SUBJECT: PUBLIC WATER SYSTEM NO. 360, JOINT BASE PEARL HARBOR
HICKAM (JBPHH) WATER SYTEM SANITARY SURVEY REPORT

JBPHH Water System No. 360
Significant Deficiency Corrective Action Photos
September 2014

SUBJECT: PUBLIC WATER SYSTEM NO. 360, JOINT BASE PEARL
HARBOR-HICKAM (JBPHH)
TRANSMITTAL OF SANITARY SURVEY REPORT

SANITARY SURVEY OF THE JOINT BASE PEARL HARBOR-HICKAM (JBPHH) WATER SYSTEM

Photo 3: Camp Smith Tank S-327 – Water level cable pipe screened

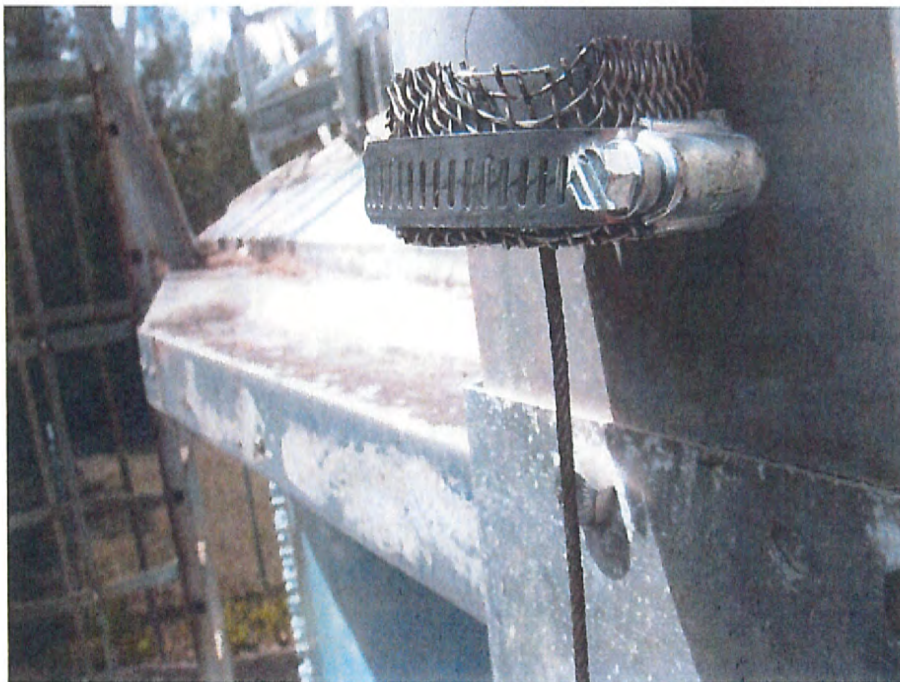
Tank 327: Plug open end of water level cable pipe.

Photo 7: Red Hill Tank – Water level assembly completely removed and plugged.

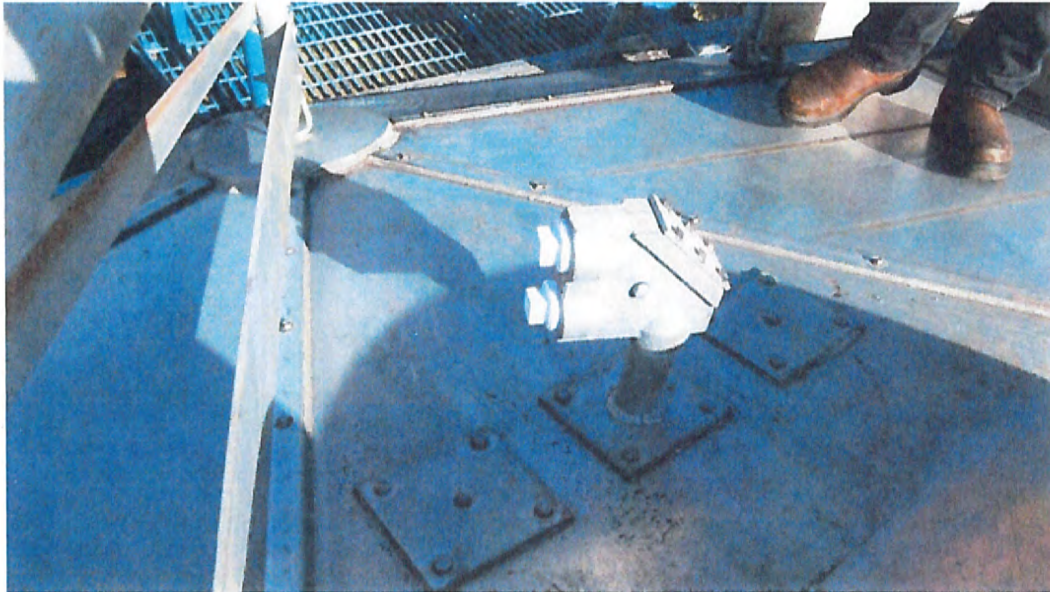
Red Hill Tank: Plug open end of water level cable pipe or completely remove water level assembly and plug any openings.
